Subject: Juniper Ridge Landfill Expansion Application, MEDEP #S-020700-WD-BI-N Follow-up to Department Staff's Responses to the March 4, 2016 Submittal on Staff's Review Comments as Presented in the Department's April 5, 2016 Letter

BGS AND NEWSME'S RESPONSE TO MEDEP'S APRIL 1, 2016 TECHNICAL MEMORANDA

I. April 1, 2016 Technical Memorandum Authored by Mr. Richard Behr

AUGMENTED PUMPS TEST FIGURES

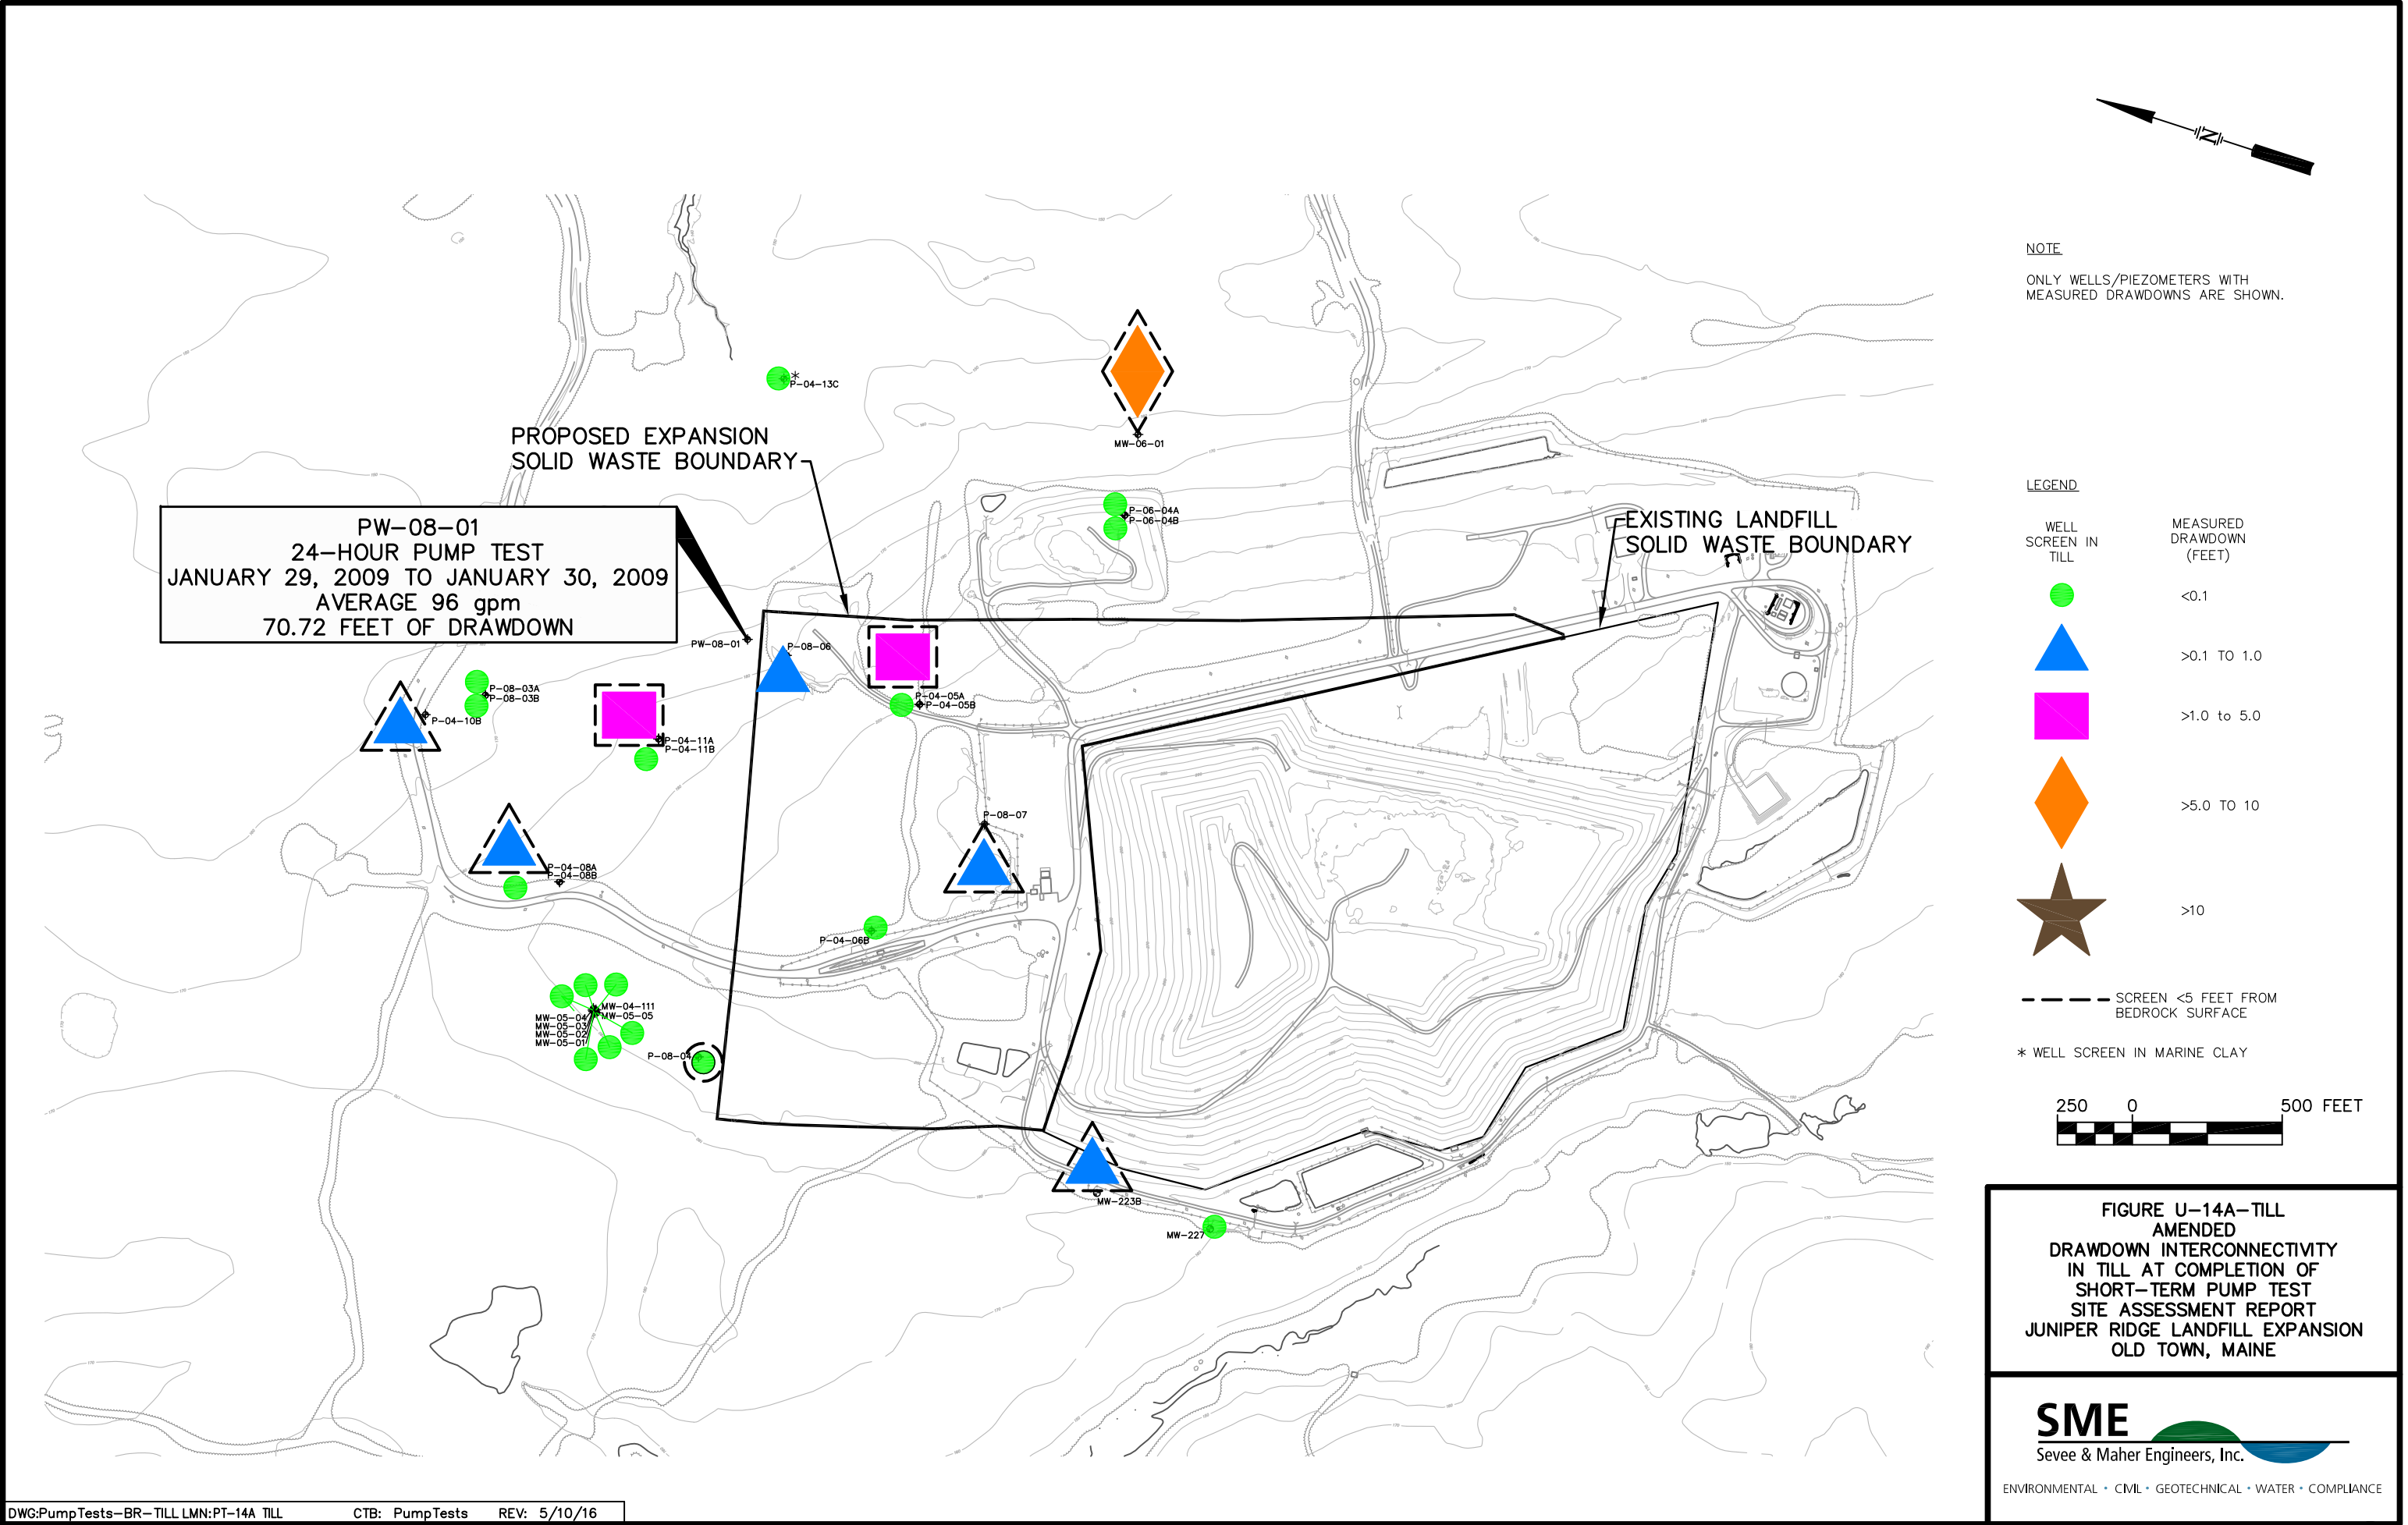
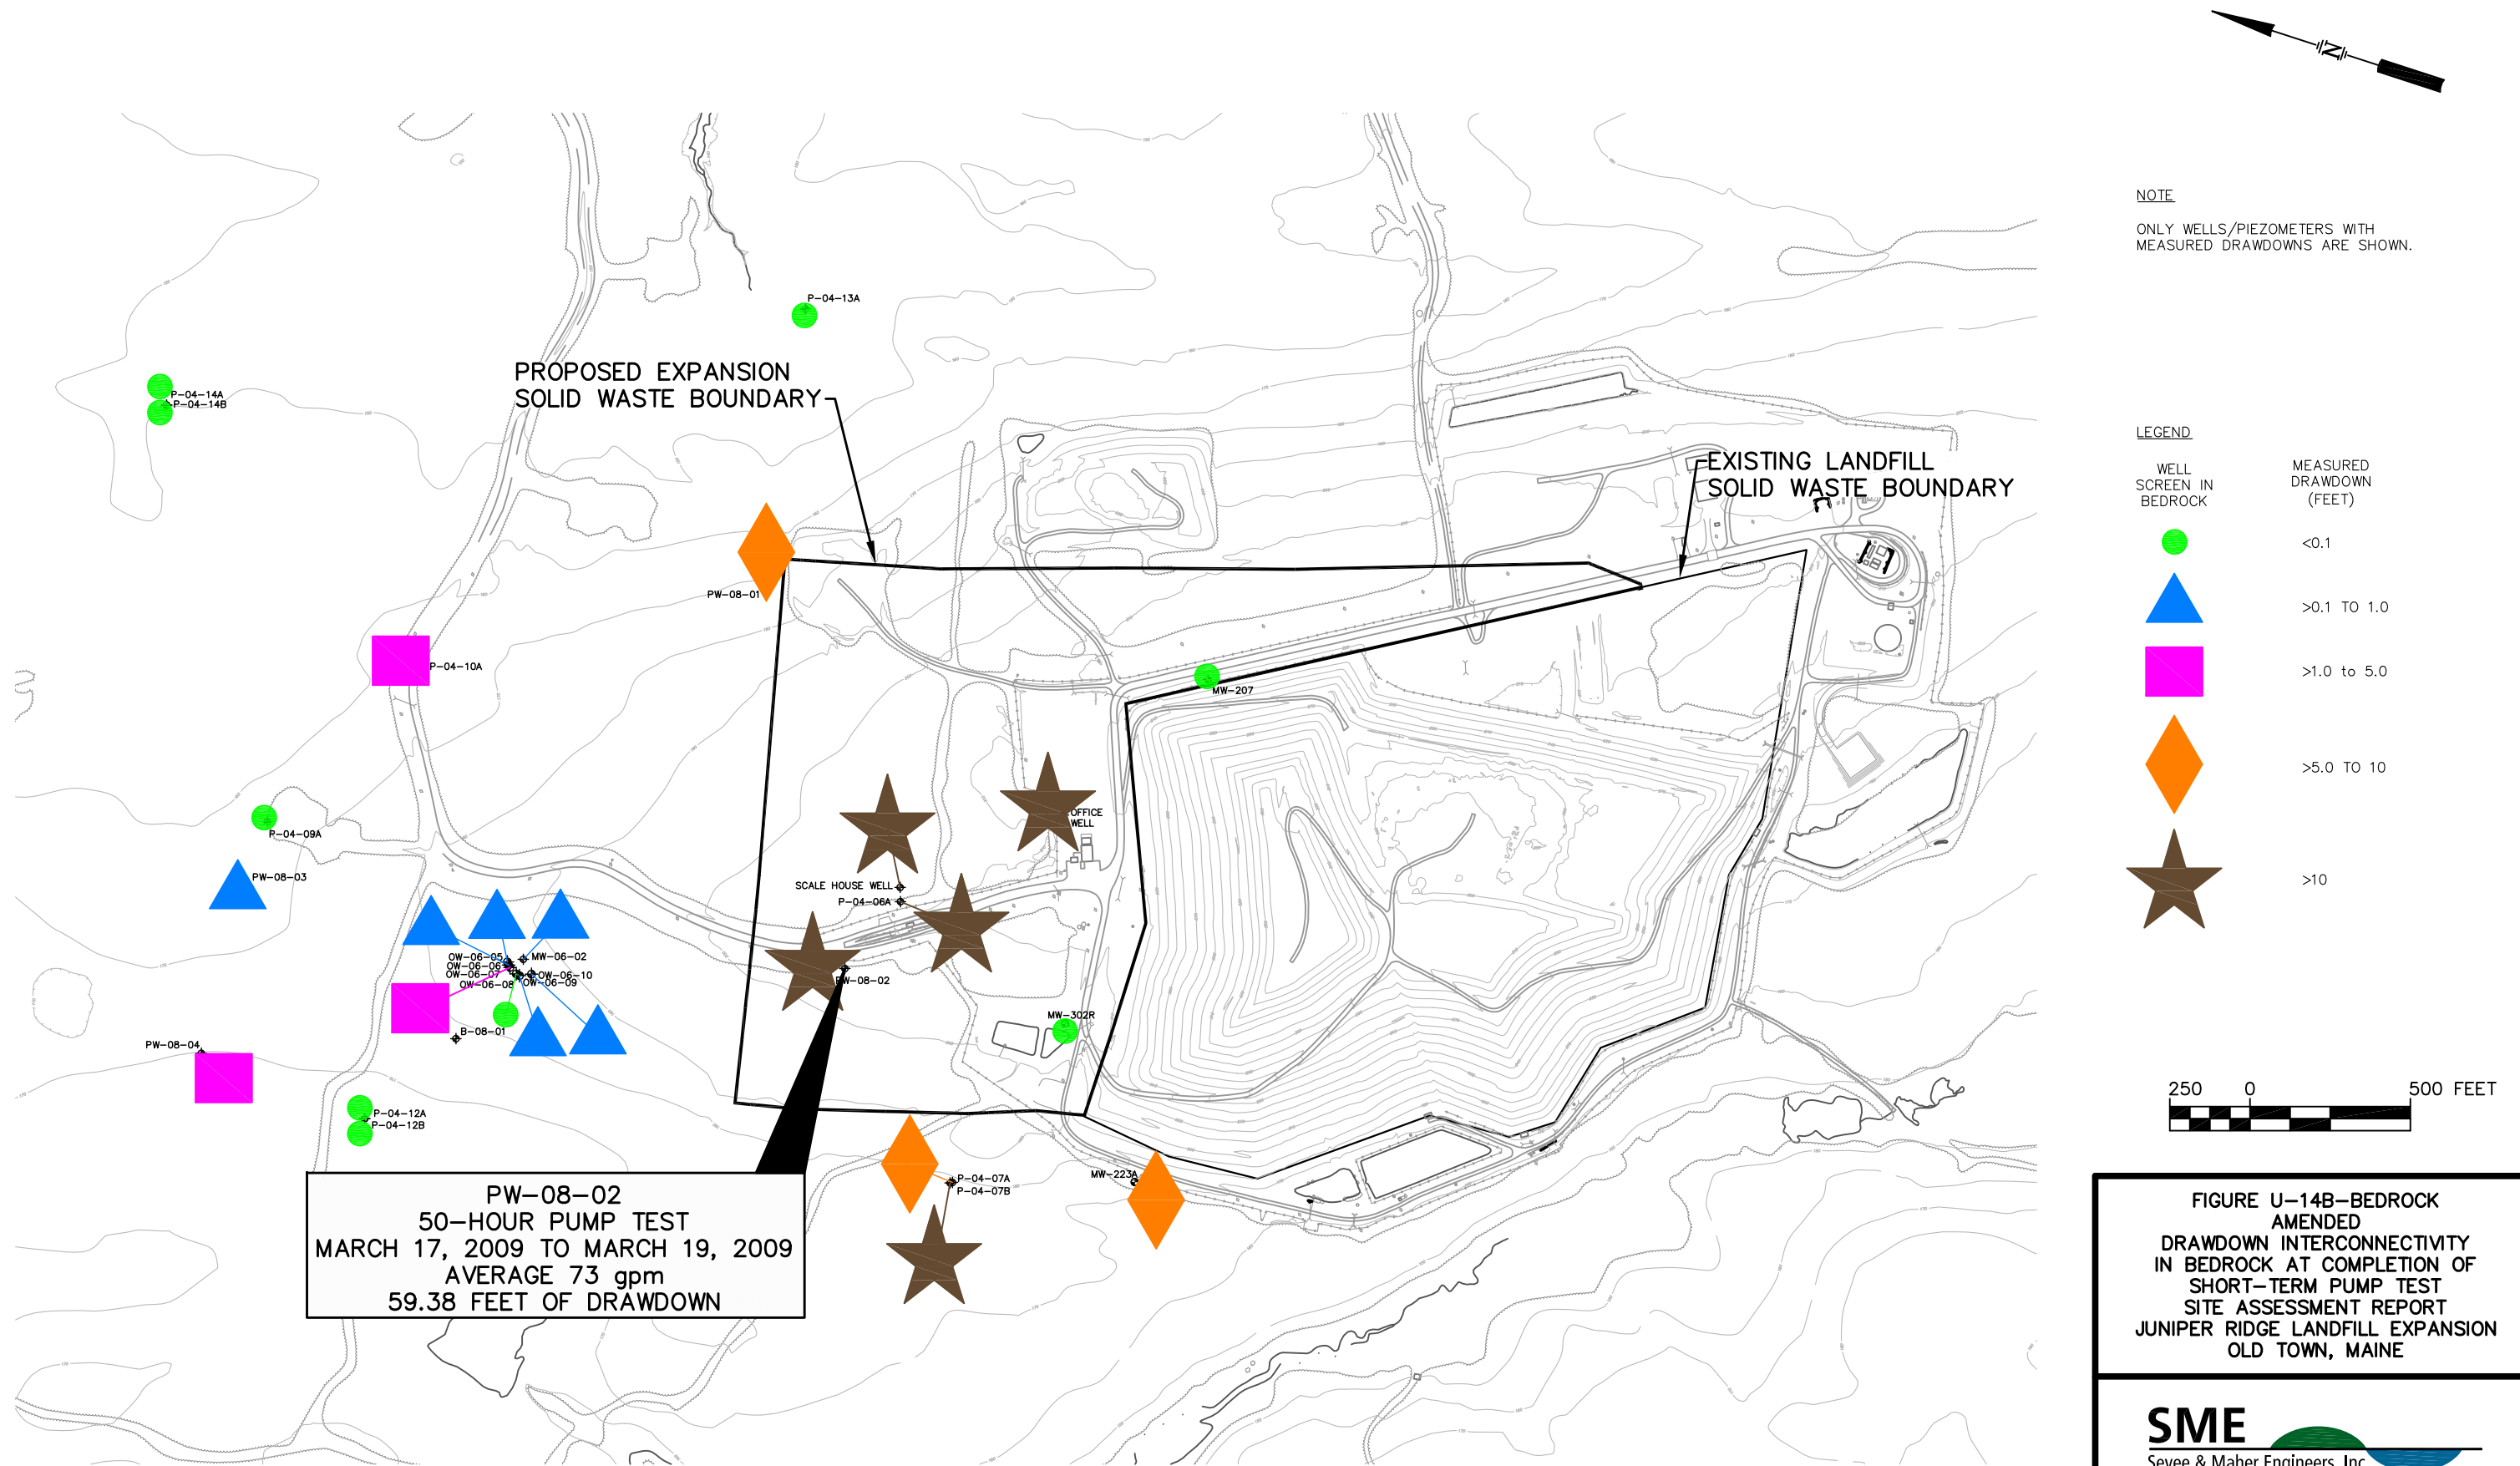
MEDEP Follow-on Response: My original comment included a request for figures to illustrate the observed drawdowns in monitoring wells screened in the till. JRL's

response did not include the requested figures. I continue to assert that a graphic depiction of locations where the till is hydraulically connected to the underlying bedrock is important and may assist in locating wells for long term monitoring and extraction wells in the unlikely event a significant leachate release were to occur.

MEDEP – Follow-on Response: The referenced figures were included in the original application but they do not differentiate the till wells from the bedrock wells. I continue to believe JRL should produce figures that depict the till wells where drawdowns were observed during the long-term pumping tests. These figures may help in the evaluation of long term monitoring well locations.

MEDEP – Follow-on Response: JRL's response to my comments about Figures U-14 and U-15 do not adequately address my comments. Additional figures are needed to properly illustrate the data collected during each of the five pumping tests. To further enhance the results of the pumping test data, it is necessary to include all of the drawdown data obtained during each test. Again, I contend it is important to differentiate between bedrock and till wells. As an example, the figure (Figure U-14) illustrating the 26.5 hour pumping test performed on PW-08-04, uses graduated symbols to depict the range of observed drawdowns for only 20 of the 53 wells where water levels were observed. There are also apparent inaccuracies on the existing figures. The text on page 26 states six wells (5 bedrock and 1 till) experienced between 0.1 and 1.0 foot of drawdown although Figure U-14 only depicts three wells in this range. The figure (Figure U-15) depicting the drawdowns observed during the long-term pumping tests at PW-08-01 and PW-08-02 also requires revisions as only a fraction of the drawdown data is depicted on this figure. Although JRL collected drawdown data for 53 wells during the tests, Figure U-15 only depicts data for 21 wells.

To address these comments, I recommend JRL display all of the drawdown data for each pumping test on appropriately scaled figures. I also ask JRL to augment the drawdown data included in Appendix M with a table summarizing the total drawdown observed in all wells during each of the pumping tests. This table would include those wells instrumented with pressure traducers and those where manual water levels were made. I am certain JRL has previously compiled this data to complete the pumping tests analyses. I also request that JRL also provide the Department with an electronic copy of the spreadsheet.

Applicants' Response: Included in Attachment SME-D3 are ten figures augmenting Figures U-14 and U-15 included in Appendix U of Volume II of the Application. These figures show monitoring wells and piezometers where drawdowns were measured during the pumping tests. For each pumping test two figures, one showing the drawdown in the bedrock, and one showing the drawdown in the till, have been prepared. On the figures showing the drawdowns in the till the locations where the instrument screen is located within five feet of the bedrock surface are identified.

Applicants' Response: See previous response to the comment regarding Appendix U, Pg 25, 5.0 Pump Test Proof of Bedrock Interconnectivity. These figures are contained in Attachment SME-D3.

Applicants' Response: See previous response to the comment regarding Appendix U, Pg 25, 5.0 Pump Test Proof of Bedrock Interconnectivity. The augmented U-14 and U-15 figures are contained in Attachment SME-D3.
